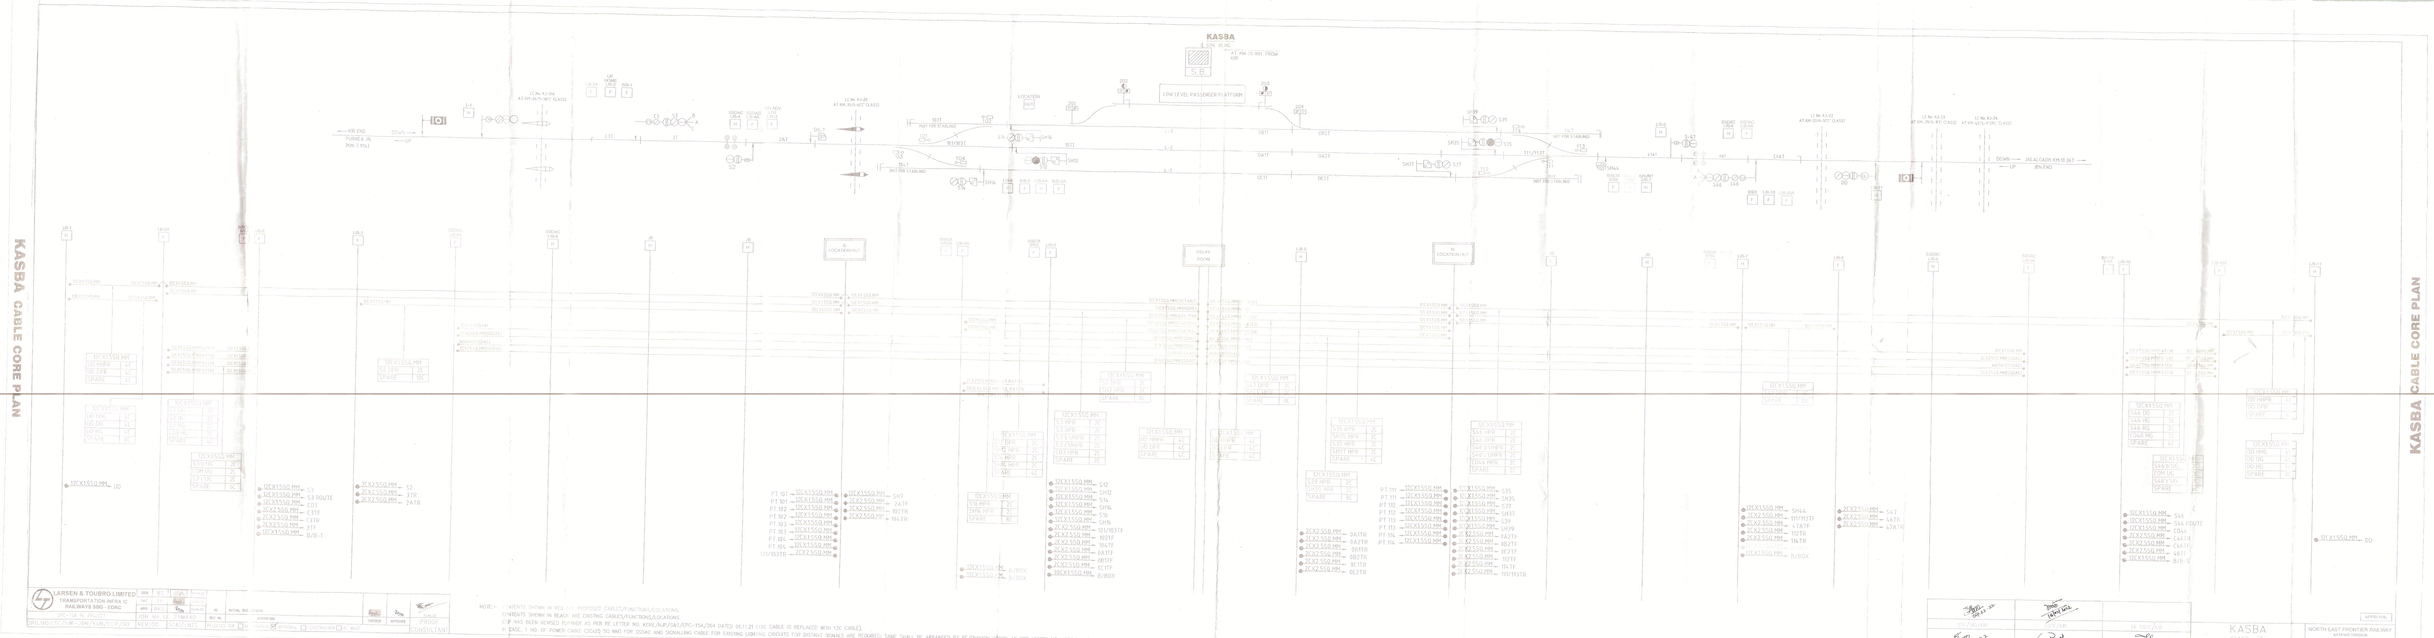
NOTE:- CONTENTS SHOWN IN RED ARE PROPOSED CABLES/FUNCTIONS/LOCATIONS.
CONTENTS SHOWN IN BLACK ARE EXISTING CABLES/FUNCTIONS/LOCATIONS.
C/P HAS BEEN REVISED FURTHER AS PER RE LETTER NO. KGRE/NJP/SAT/EPC-15A/264 DATED 06.11.21 (10C CABLE IS REPLACED WITH 12C CABLE).
IN CASE, 1 NO. OF POWER CARE (3X4Z5 50 MM) FOR 3DOAC AND SIGNALLING CABLE FOR EXISTING LIGHTING CIRCUITS FOR DISTANT SIGNALS ARE REQUIRED, SAME SHALL BE ARRANGED BY RE/DIVISION VIDE AS PER LETTER NO. KGRE/NJP/SAT/EPC-15A/264 DATED 03.11.21.
